GeoSolve Ref: 220556.03  
26 November 2025

RCL Homestead Bay Ltd  
[REDACTED]

## Request for Further Information - Homestead Bay Lot 12 DP 364700

Figure 1. Site investigation Plan for the eastern area of Lot 12, and the north eastern corner of Lot 8.

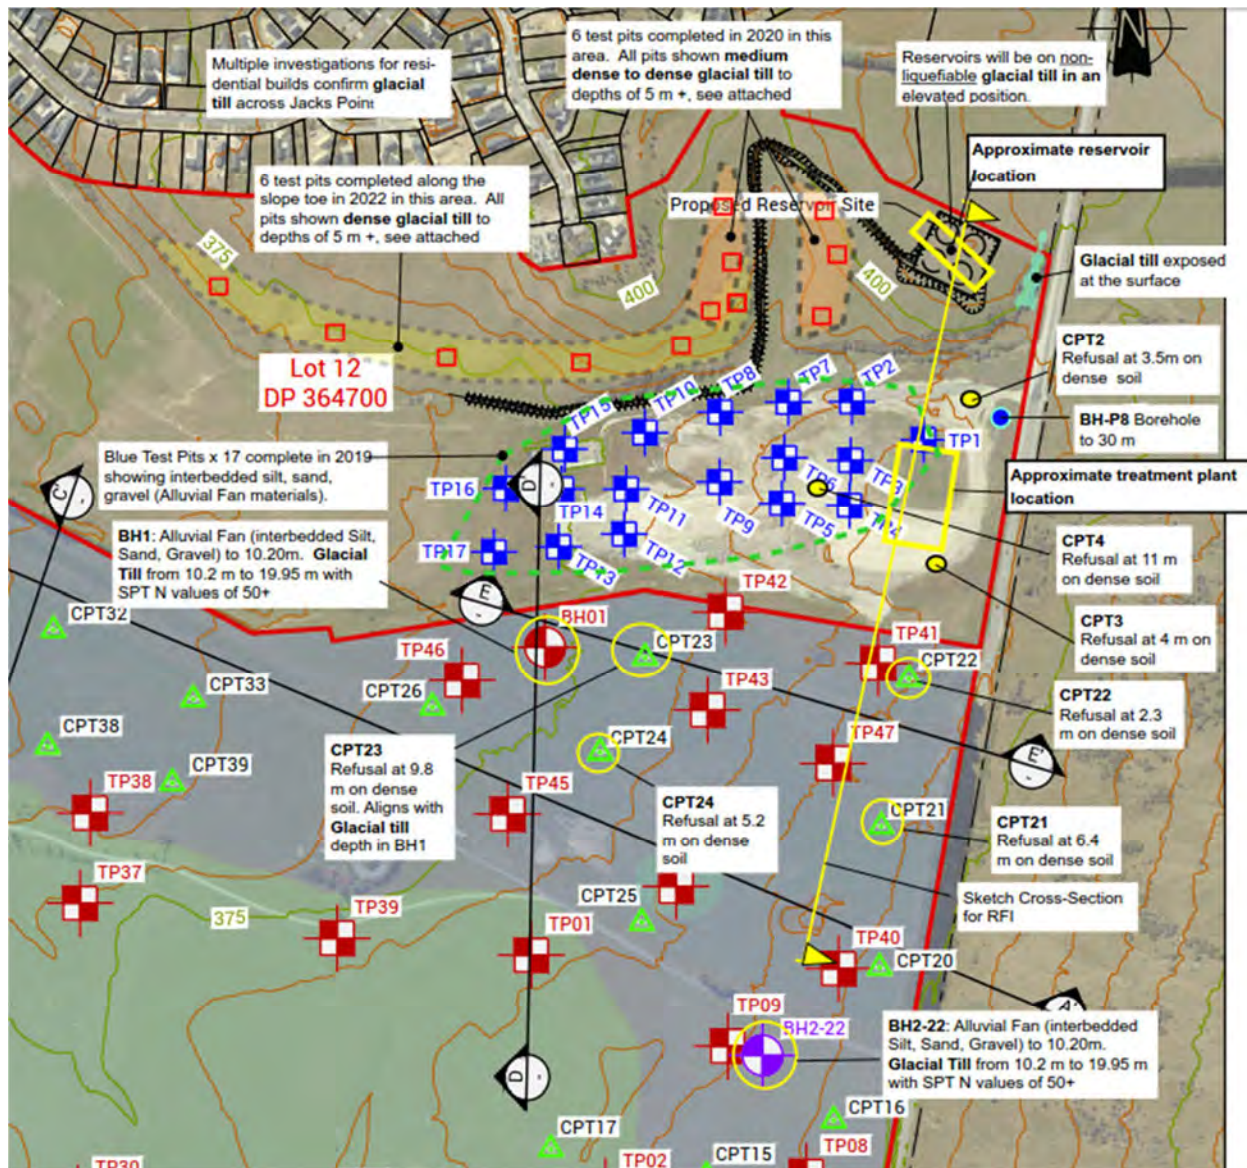
20. The applicant needs to confirm the level of detail of the liquefaction assessments for both the reservoir site and the WTP/WWTP site in accordance with MBIE (2017) and demonstrate that it is suitable level for this stage of the consent.

Geosolve have undertaken 4 specific deep investigations and multiple test pits across the infrastructure area in various stages. Wider data and surface mapping has also been

utilised to determine the geological model, see Figures 1 and 2, Appendix A, which shows the nearby investigation locations, mapped exposures and interpretation. Based on this data adequate characterisation of the ground conditions is considered to have been presented, as discussed above. Geosolve consider the assessment to be equivalent to a Level C detailed area wide assessment with respect to the eastern area of Lot 12 and the proposed infrastructure locations.

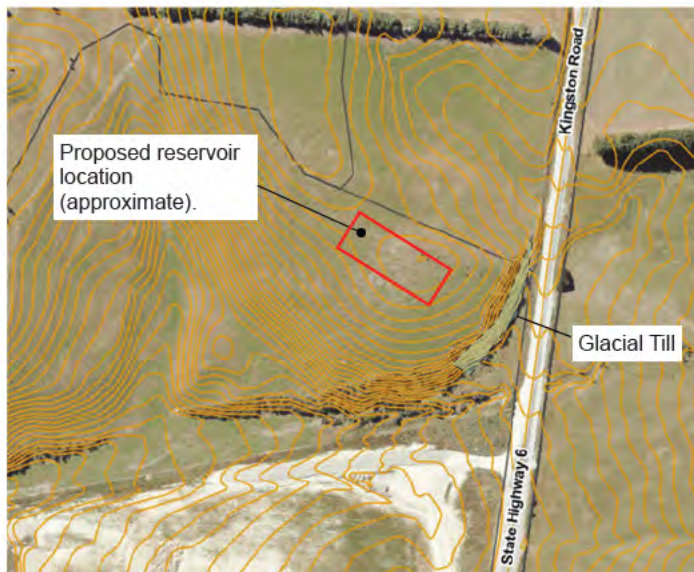
<b>Reservoir Site (Lot 12 - north)</b>	
16.	The applicant says that the site is glacial till and is therefore a low risk to liquefaction. As part of the TTSC, QLDC geotechnical consultant undertook a liquefaction hazard assessment as per the MBIE (2017) 'Planning and engineering guidance for potentially liquefaction-prone land' guidance. The TTSC report is <b>attached</b> to this response.

17.	For the reservoir area the assessment level of detail is in accordance with 'Level A' basic desktop assessment. No physical investigations were undertaken as part of the TTSC study, but that area near the reservoir was also mapped as Glacial Till. It is agreed that glacial till is unlikely to result in liquefaction, however, the Applicant references test pits that were done near the site. These referenced test pit logs or physical investigation that confirm it is glacial till cannot be seen in the initial application nor the additional information provided. As part of this consent, physical investigation should support geotechnical assessment.

See the geotechnical investigation data provided in Appendix B which confirms Glacial till is present in the proposed reservoir area.

Glacial Till is exposed along the eastern side of the low hill present in the northern part of Lot 12, and directly to the east of and below the reservoir location, as shown on Figure 1, appendix A, and on the image below.

DRILLHOLE No: BH P8

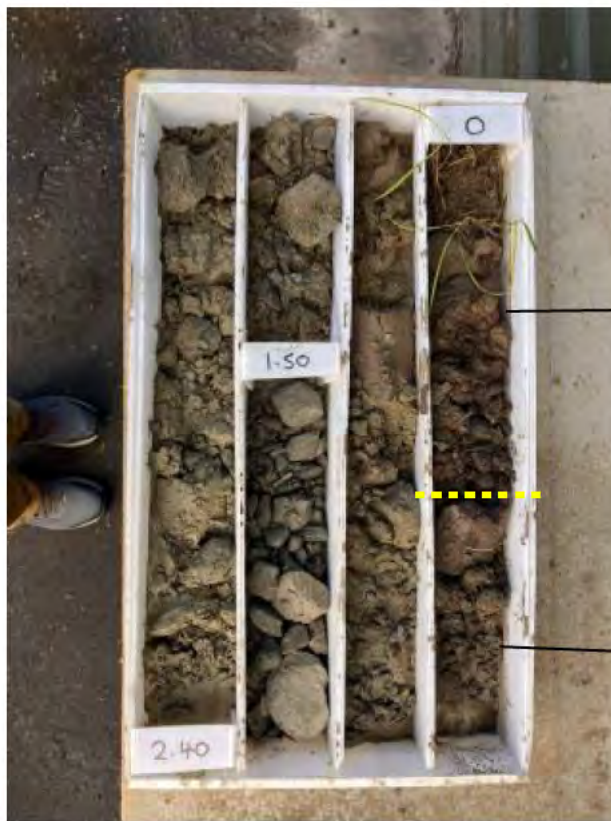
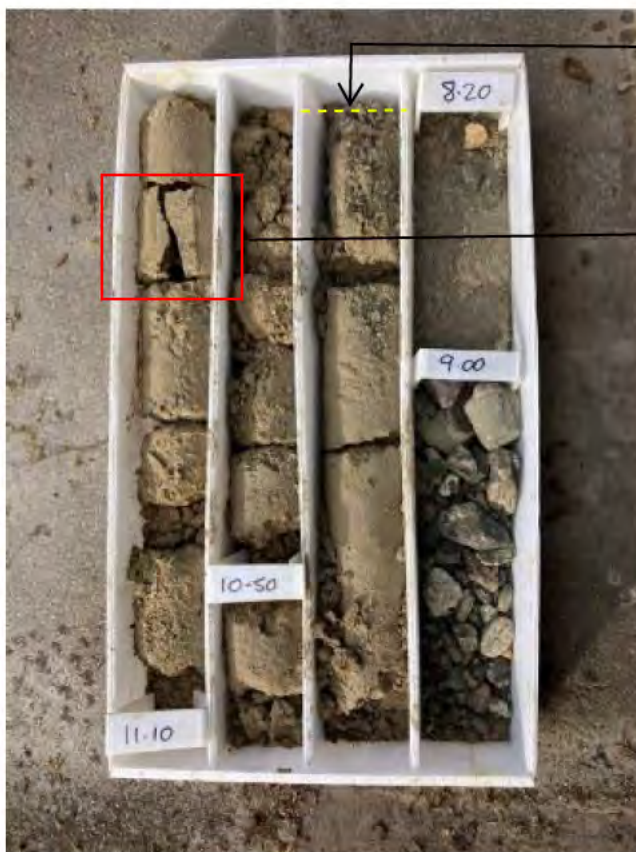
(d)	It is unclear if SPT (Standard Penetration Test) testing was undertaken at the bore hole that was drilled to 30m, or if this was just to inform the water depth. Confirmation and justification (if required) as to why no SPT was undertaken in the borehole, given refusal was met in CPT2 & 3, is needed to understand whether the data is reliable.

d) The drill hole was undertaken for water monitoring purposes and SPT testing was not undertaken. The core was made available to Geosolve and a geotechnical log and core photographs are provided in Appendix C. Refusal of the CPTs on dense glacial till or coarse granular layers in the overlying alluvial deposit is indicated by the drill core.
